GENERAL LAND USE APPLICATION

| Case #: | Master File #: | Date: 7/2/18 JL | | |
|---|---------------------------|--|--|--|
| Project Name: Village At Mill Pon | | | | |
| Project Description: Amendments to the Design Criteria for the Village At Mill Pond - Master Plan. See attachment for proposed amendments. | | | | |

The Village At Mill Pond Design Guidelines - Explanations

里

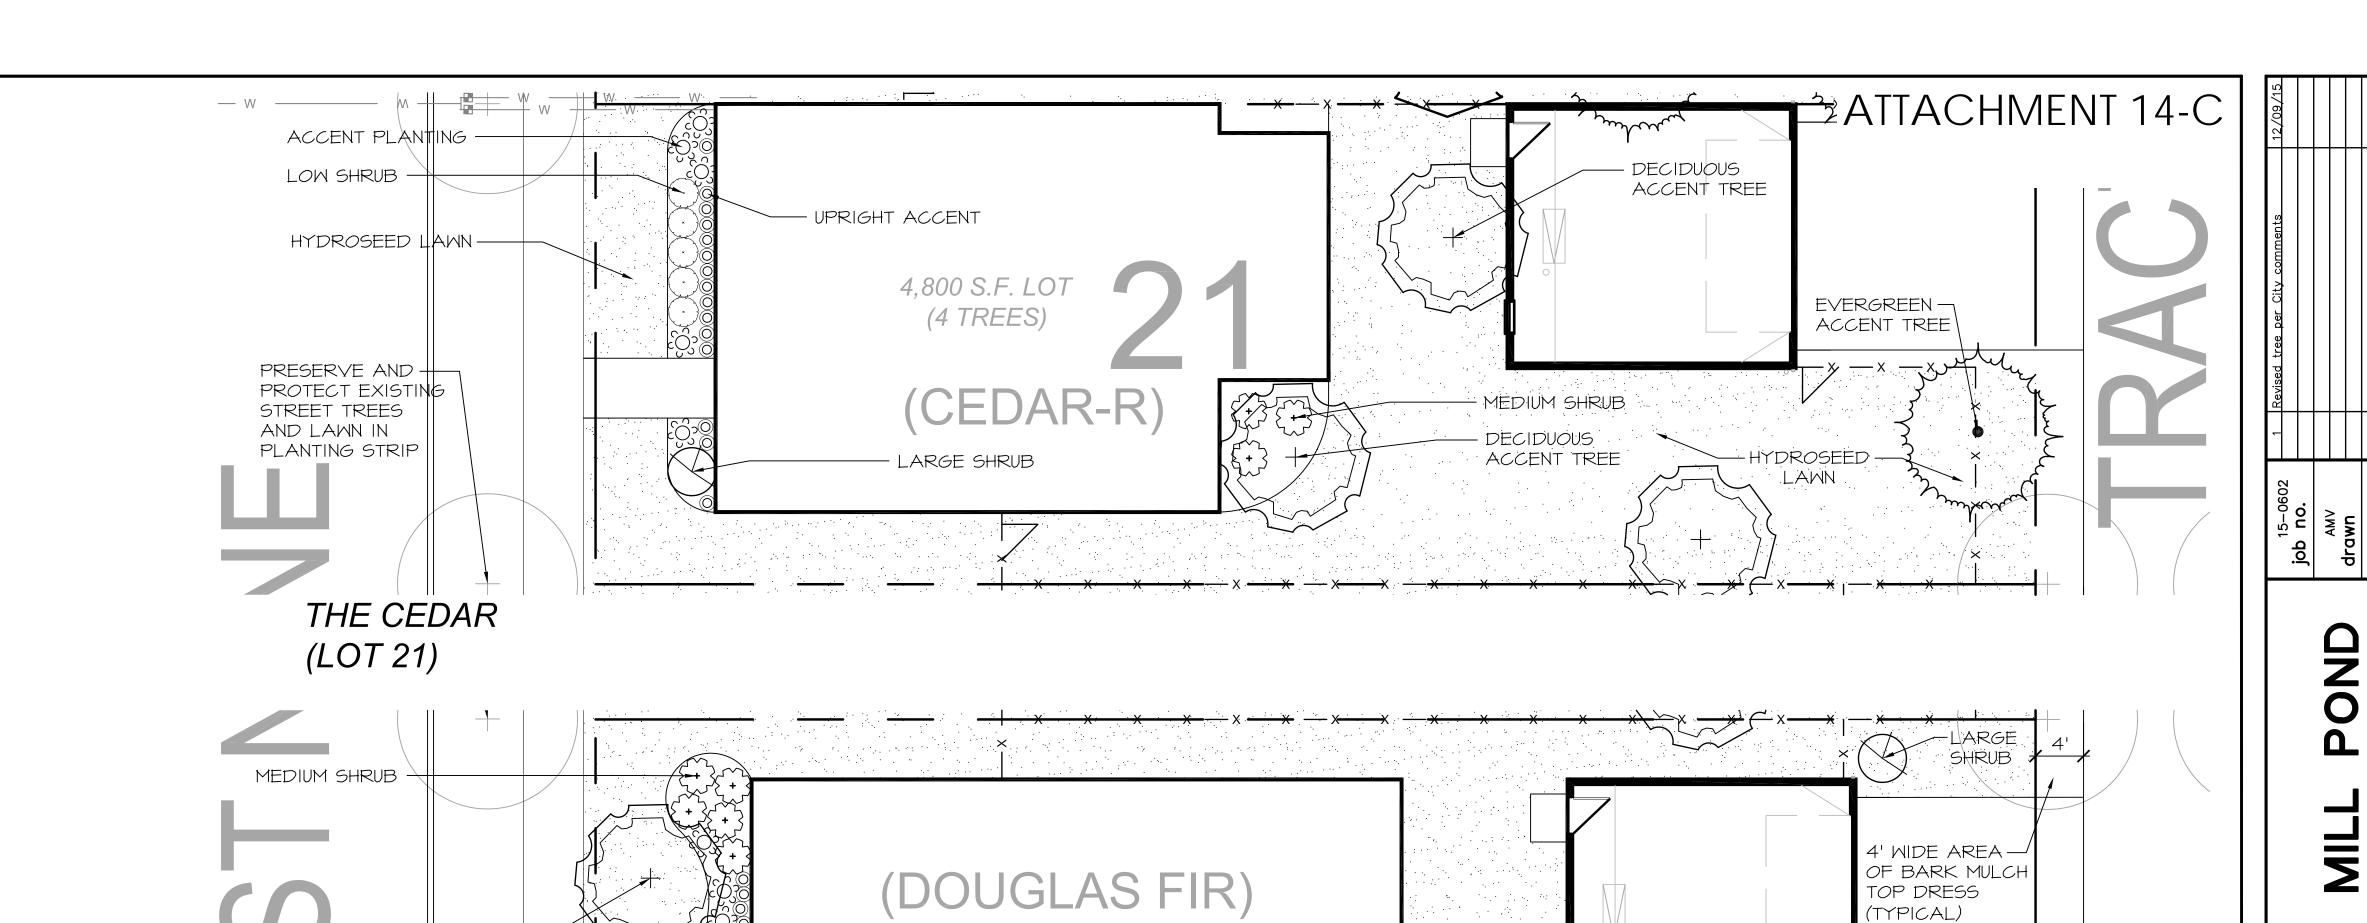
Develop landscape in layers. Low at street level and then Provide low landscaping near sidewalks, foundation plantings at foundation, with and specimen trees as intermediate layer.

This amendment clarifies the location for plantings. The intent is not to require plantings to line the entire length of the street, it is simply a criteria for size of plantings at each specific zone around the lot.

See Attachment 14-A through 14-G for example landscape plans and planting types for typical model houses

ATTACHMENT 15A-A

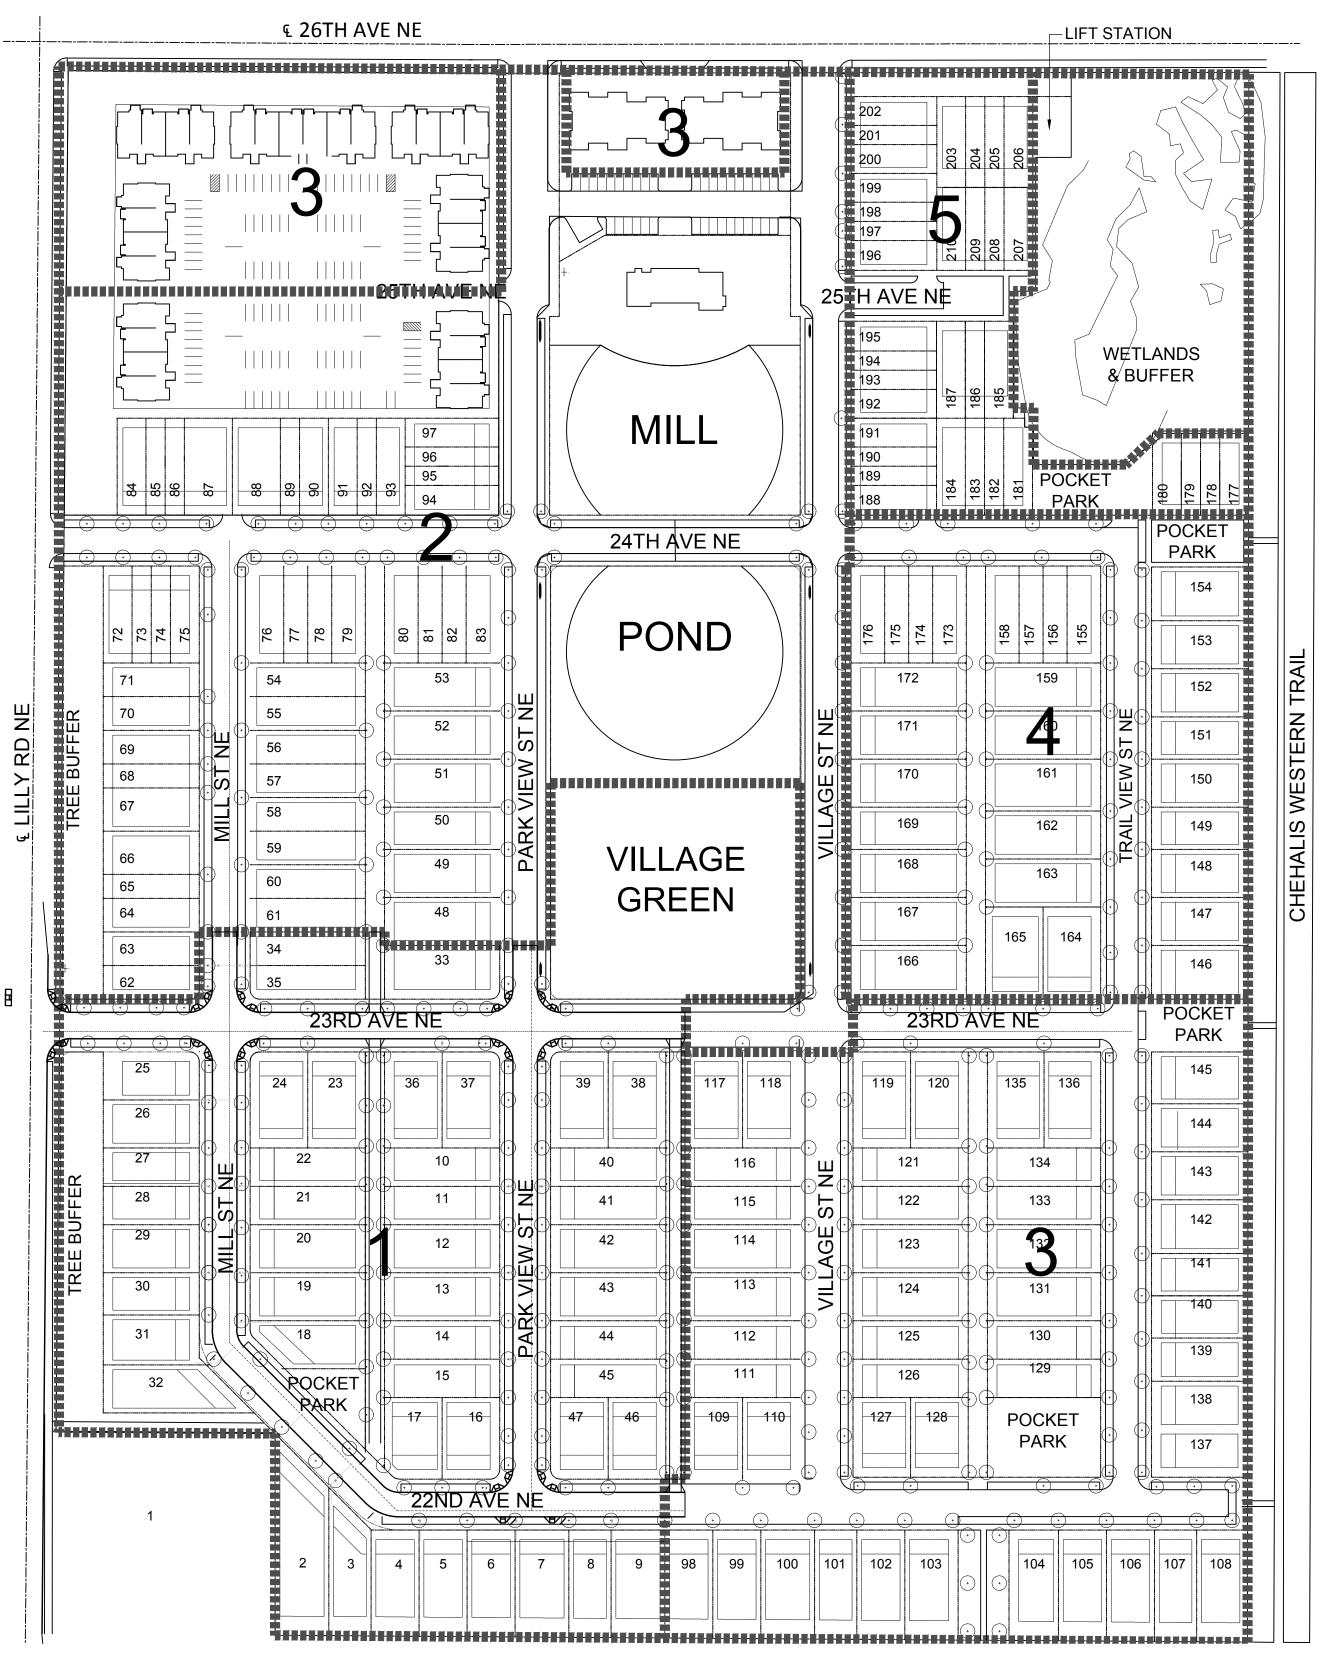
By adding this criterial a secondary roof slopes at rear or side of the single-family homes could be of a lower slope to accommodate variety in massing allow for flexibility to adjust to various floorplan layouts. These slopes would be perpendicular (90 degrees) to the primary slope and would not be allowed to face the street or open public areas.

Example of 6:12 slope roof that could benefit to be a 5:12 roof slope. By lowering the slope the overall mass of the garage is reduced and becomes less dominating on the rear facade.

Reduce gable at rear entrance (off alley) from 6:12 to 5:12.

- -Reduce scale of rear facade
- -provide greater flexibility in floor plan layout
- -Provide greater variety in massing along vehicular drive access.
